Value Engineering Study

**Cousins Pumping Station Complex
Jefferson Parish, Louisiana**

**U.S. Army Corps of Engineers
New Orleans District**

SUBJECT: Value Engineering (VE) Study for the West Bank,
Vicinity of New Orleans, LA Hurricane Protection Project -
Cousins Pump Station Complex

DESCRIPTIVE TITLE OF RECOMMENDATION: Do not Widen Channel

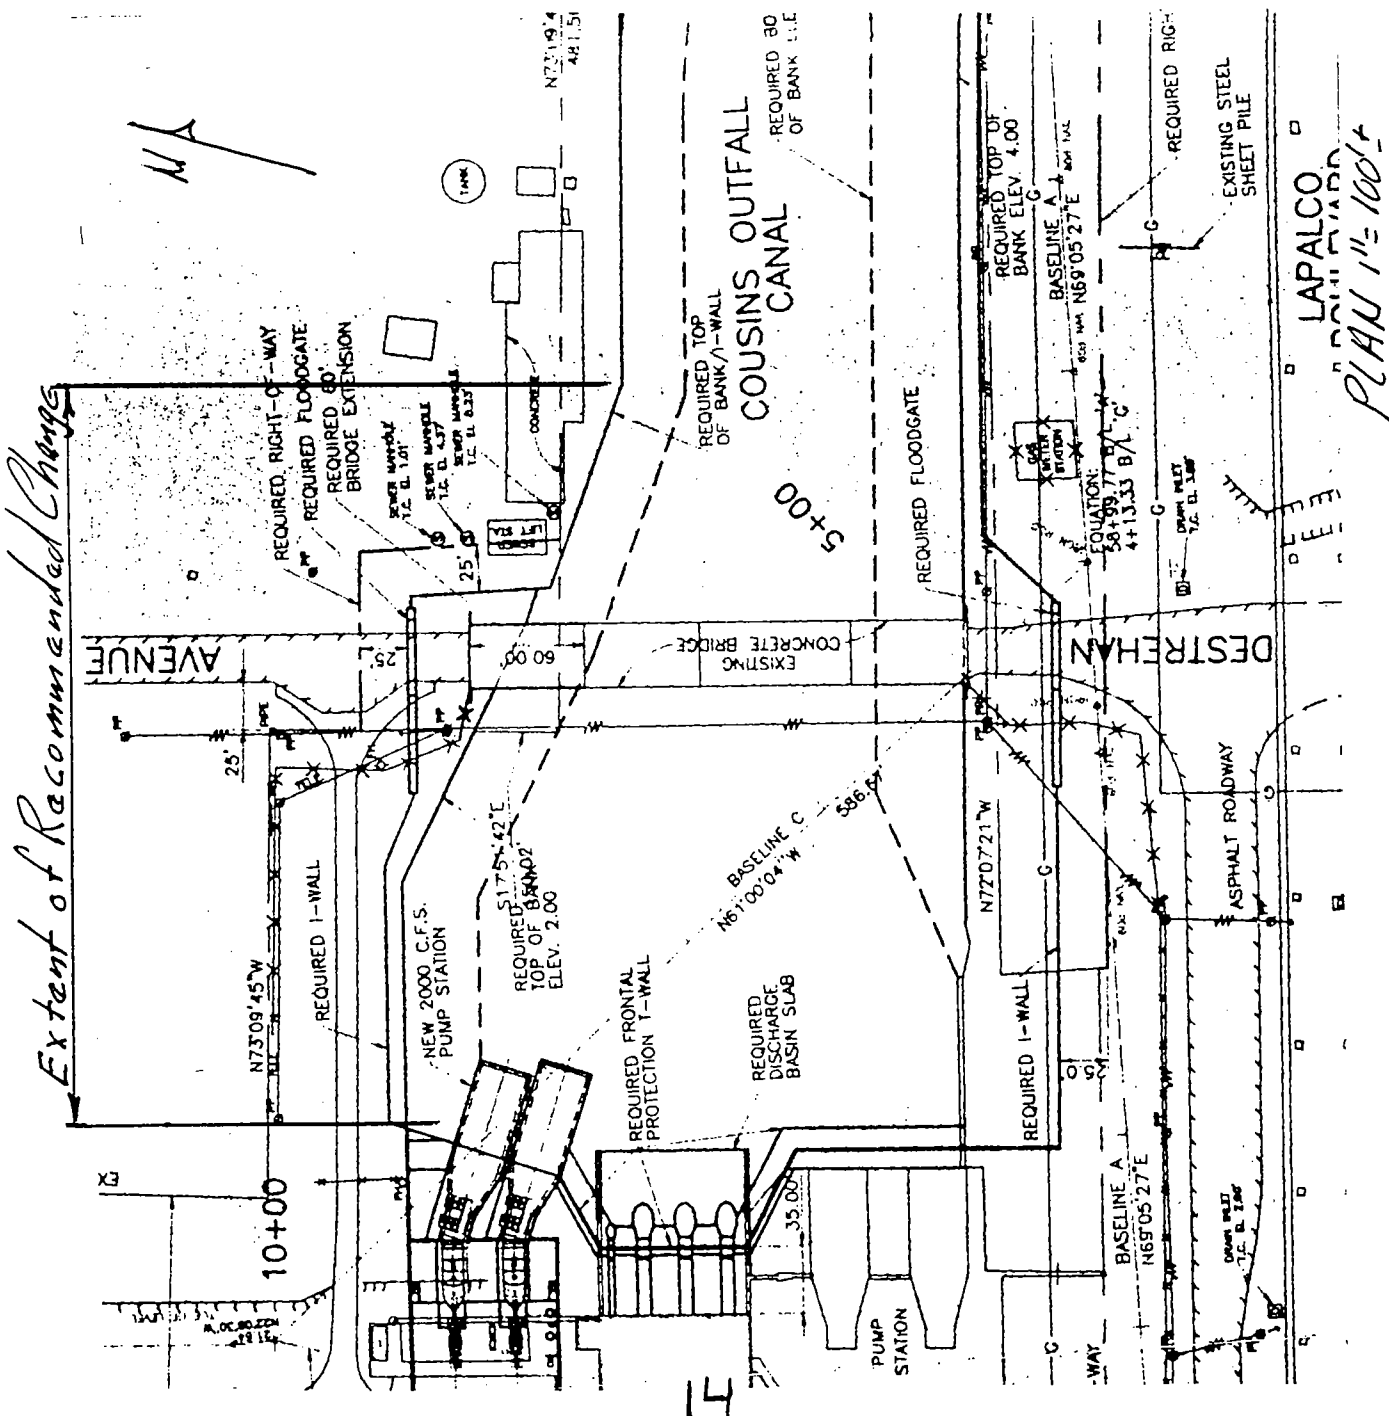
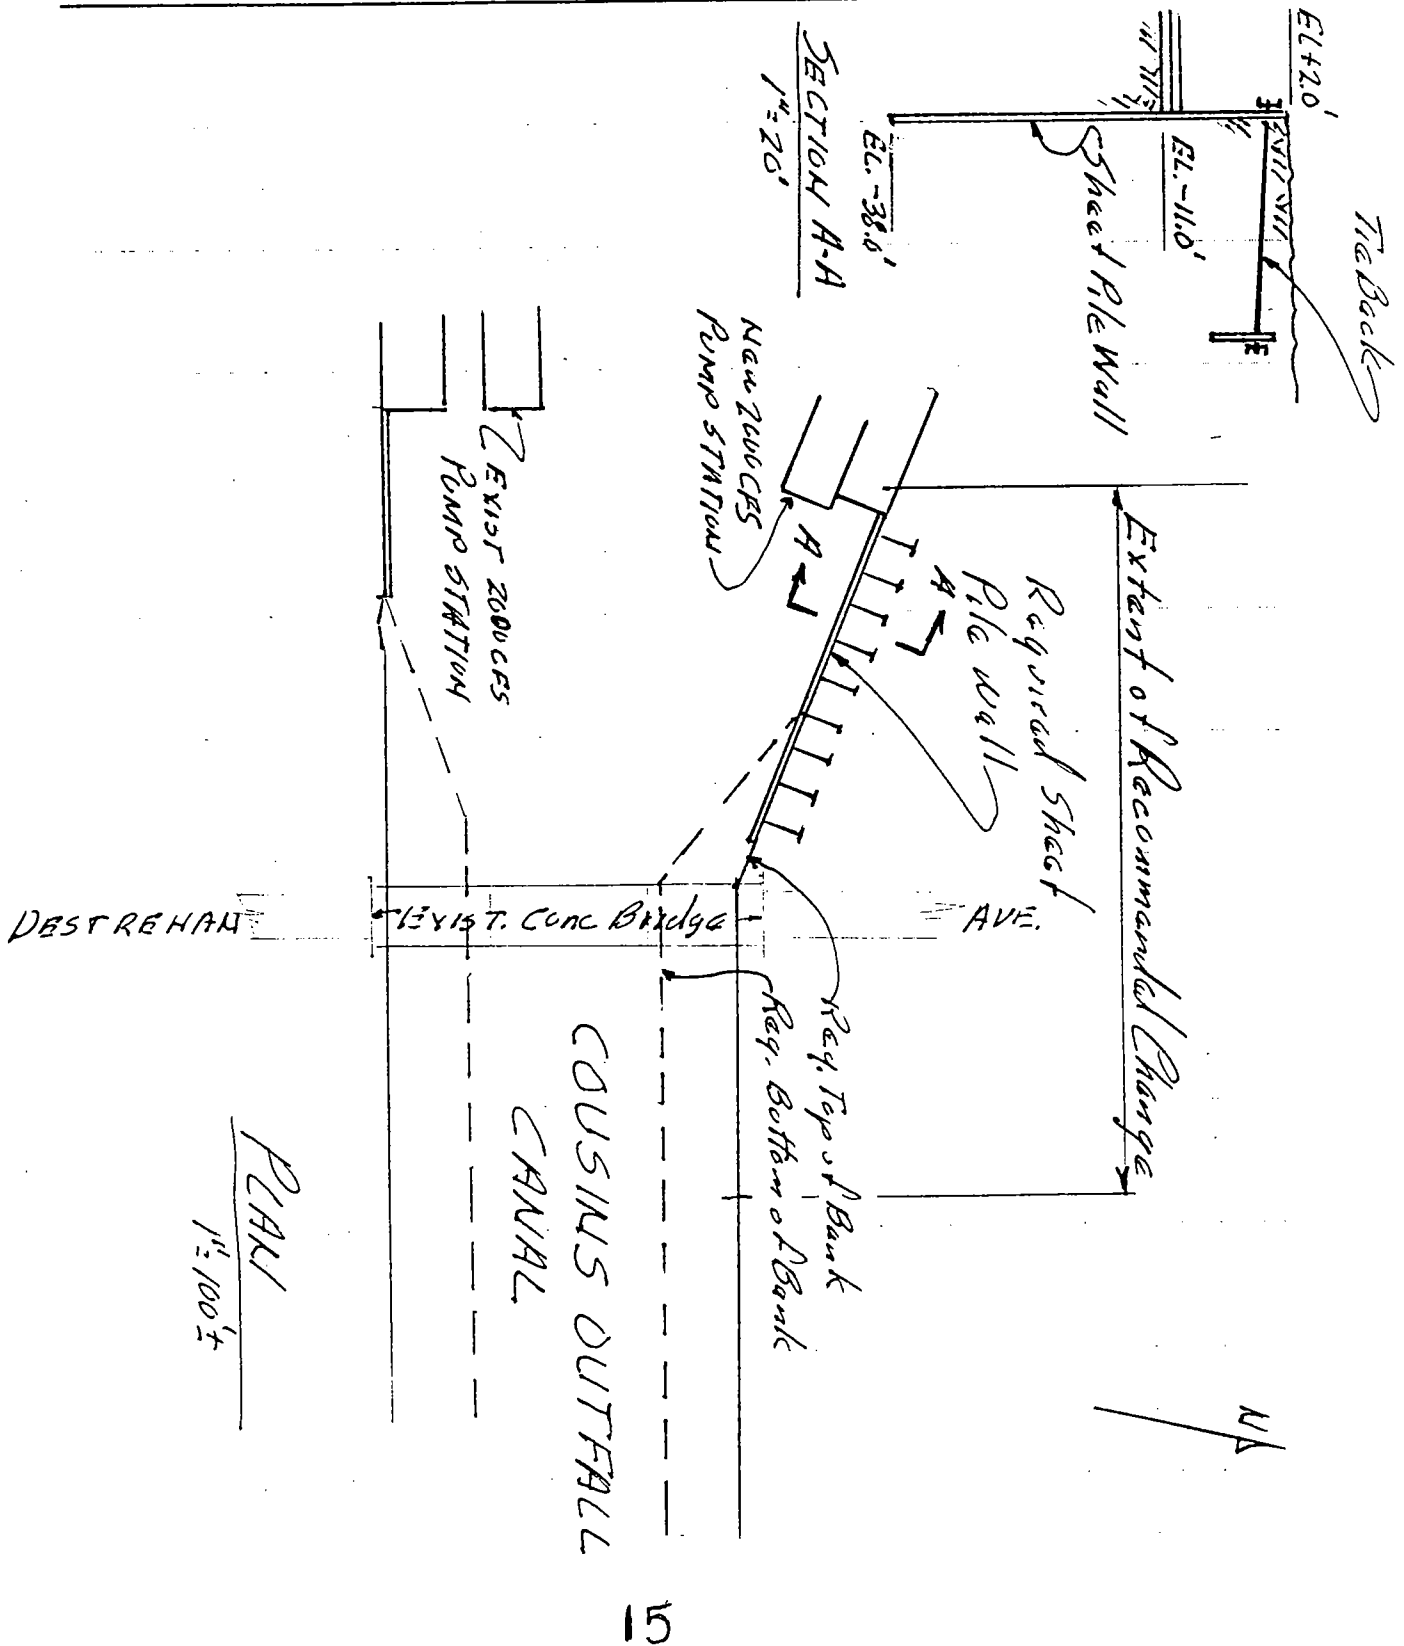
The discharge canal is widened from new 2,000 cfs pump station through the Destrehan Ave. Bridge. The added width at the bridge is approximately sixty feet, necessitating addition of a sixty-foot span to lengthen the bridge.

Maintain the existing top of bank canal width at the Destrehan Avenue Bridge, eliminating the need for lengthening the bridge. Extend the top of the bank of the widened canal in a straight line from a point just west of bridge to the north edge of the new pump station discharge tube. Approximately 175' of a sheet pile wall will be required to provide a vertical canal side near the discharge tube.

DESCRIPTIVE TITLE OF RECOMMENDATION: Eliminate Rip-Rap

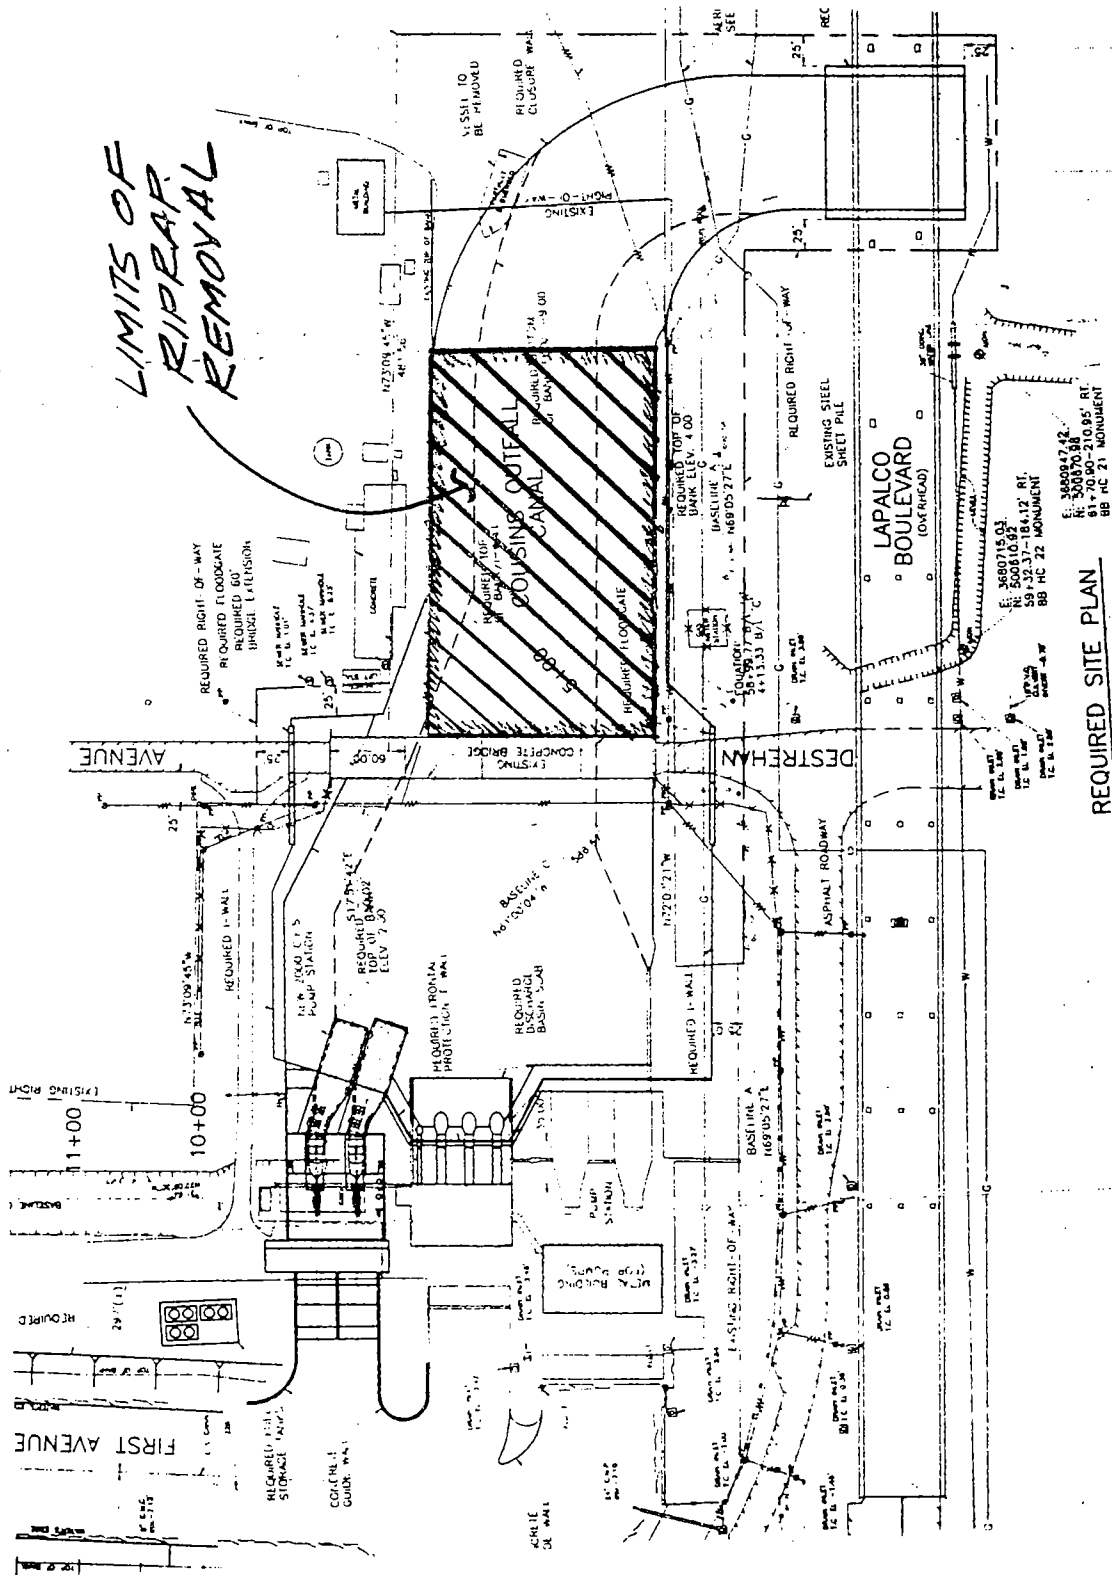
A 2'-0" thick bed of rip-rap is used throughout the discharge channel. The rip-rap covers the embankments and the channel bottom.

Remove the rip-rap between the Destrehan Avenue Bridge and the beginning of the closure wall.

RECOMMENDED
CROSS-SECTION AT LAPALCO BRIDGE

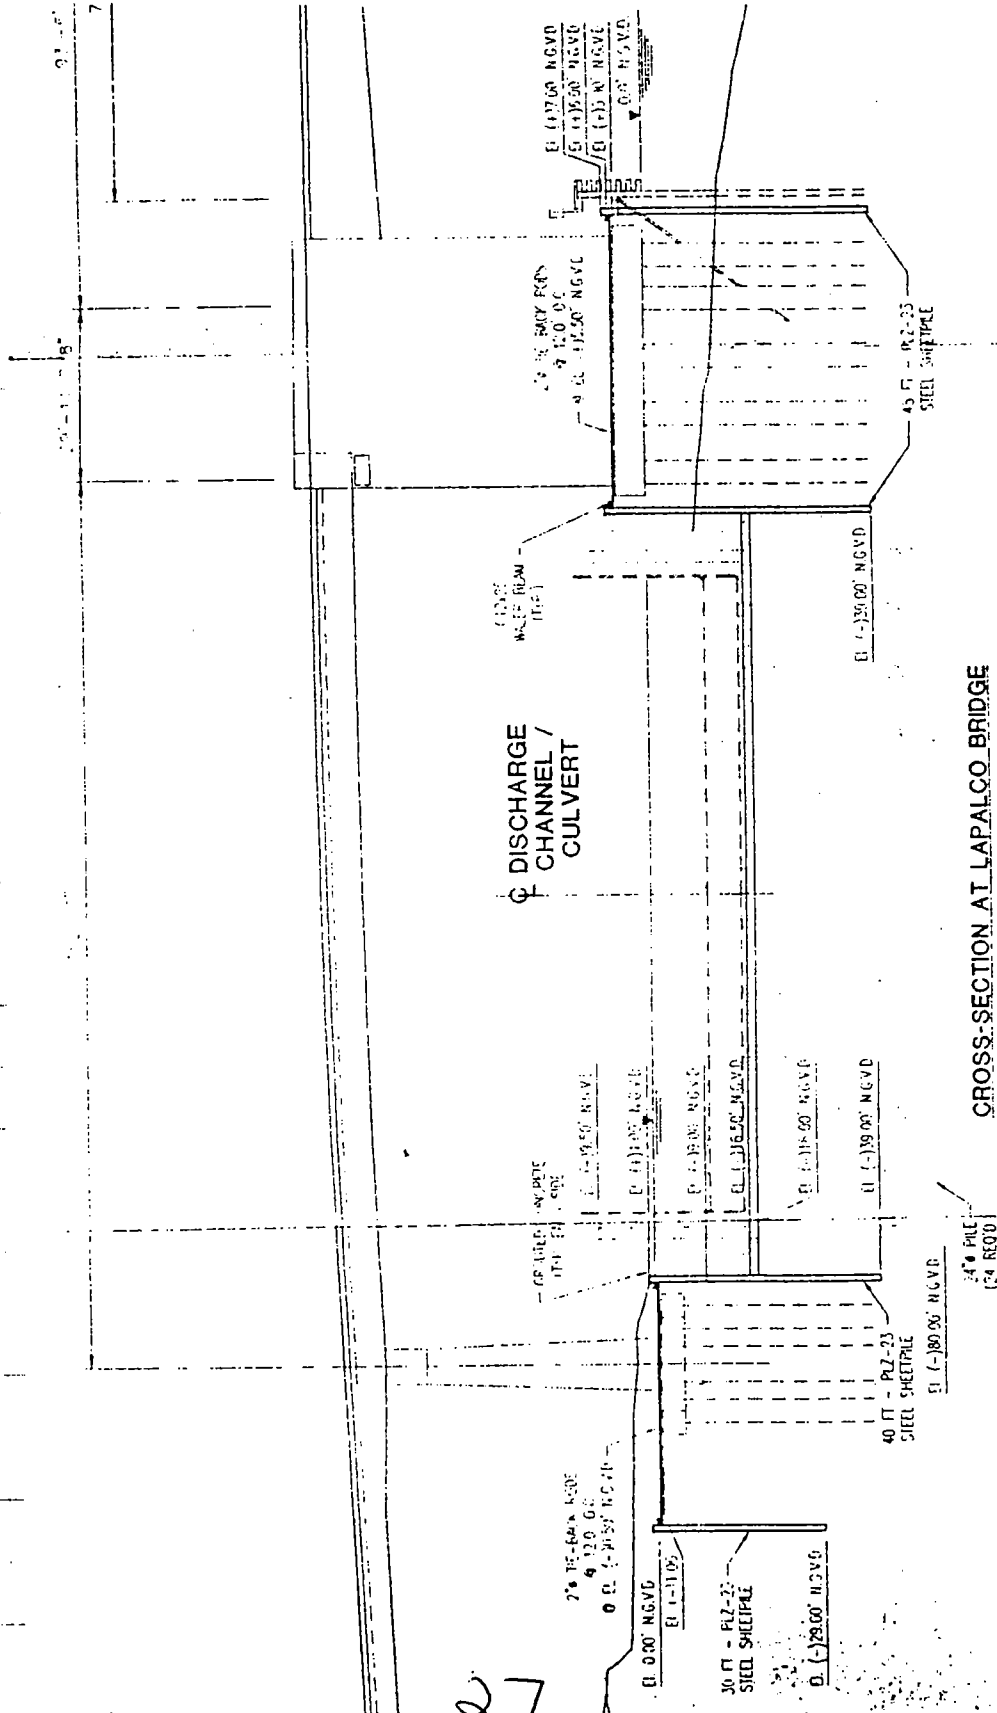
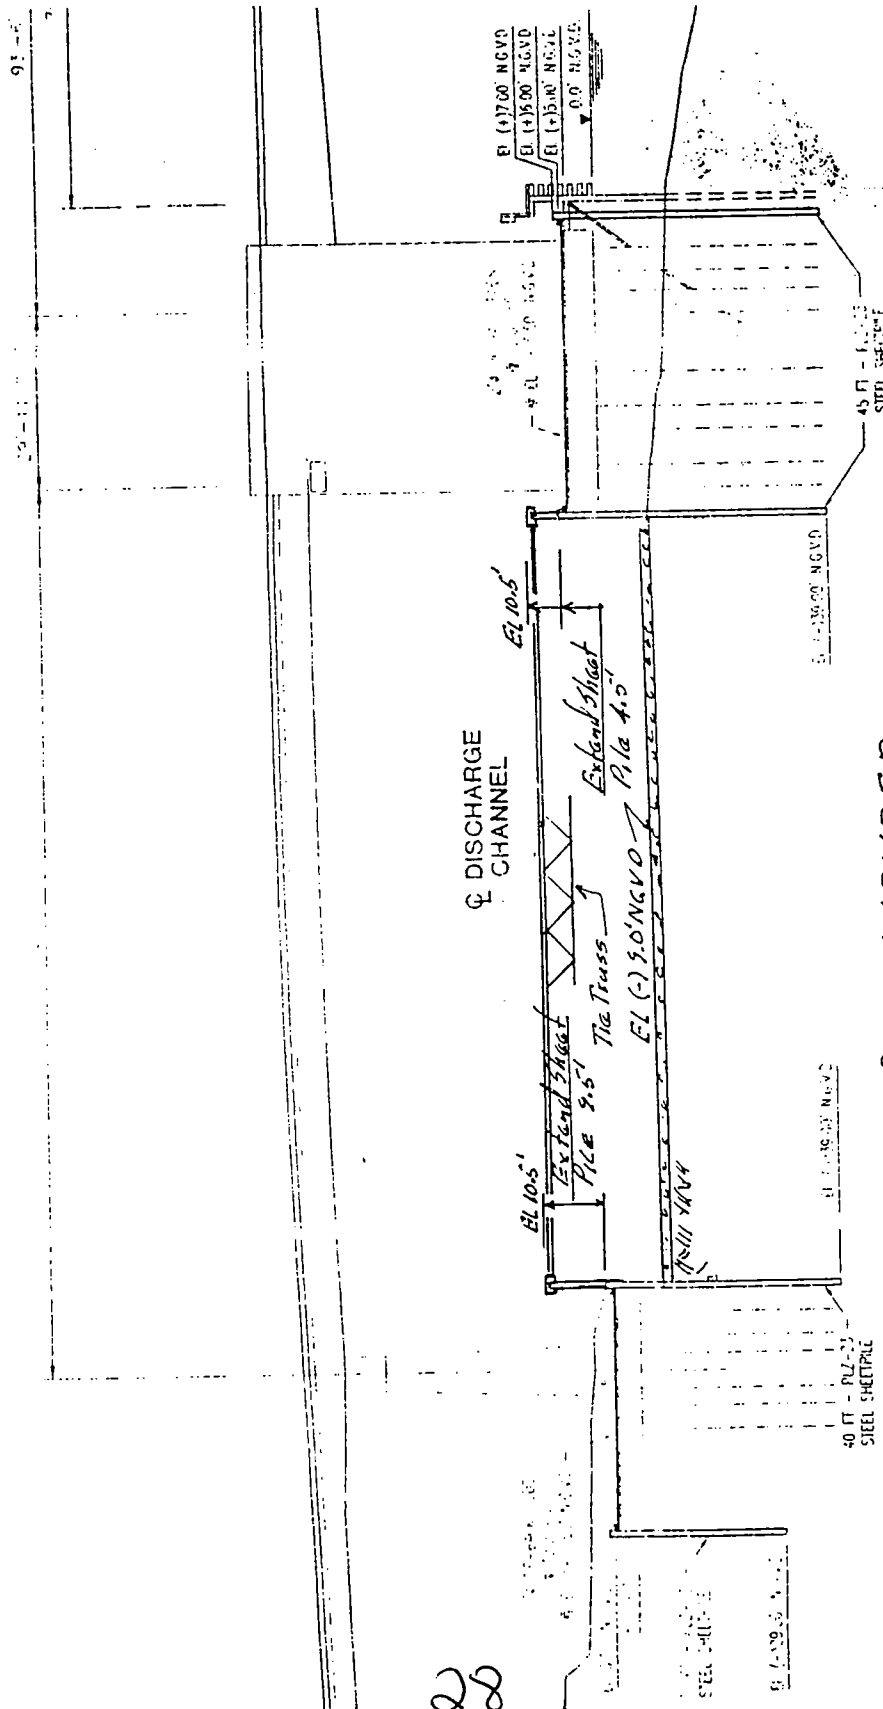
The discharge channel passing under Lapalco Bridge is an open top precast concrete flume which will be floated into place on a site prepared by dredging between tied back sheet pile walls at the bridge piers. The sheet piles also serve as cutoff walls.

Eliminate the concrete flume and attain flood protection elevation by extending the sheet piles up to the required elevation and tying the walls across the channel.
